Service Bulletin

Bulletin No.: 18-NA-301

Subject: Service 4WD Lamp Message Displayed - DTC C119B 04, P0700, and/or P2534 Set

Brand:	Model:	Model Year:		VIN:		Engine:	Transmission:
		from	to	from	to		
Chevrolet	Silverado 1500 (New Model)	2019	2019			L84, L87	
GMC	Sierra 1500 (New Model)

4698775

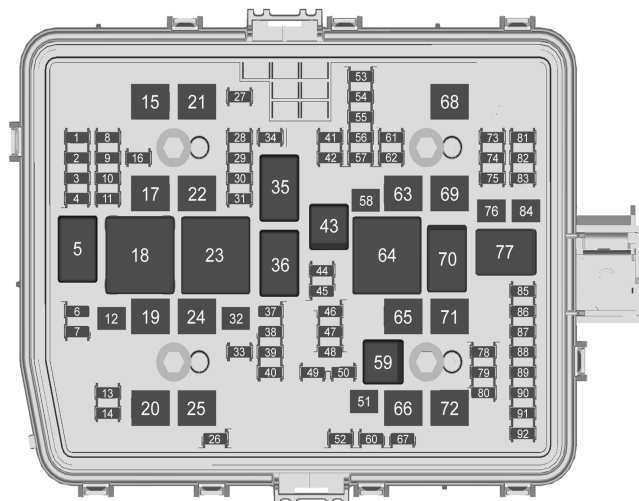
Locate fuse #47 and/or #83 in the Front Compartment Fuse Block. Refer to Document ID: 4694932 in SI.

- Replace fuse #47: Transmission control module ignition with a 10A fuse.
- Replace fuse #83: FTZM with 30A fuse.
- Install new fuse block cover.

⇒ New cover reflects the changes to the fuses for two circuits.
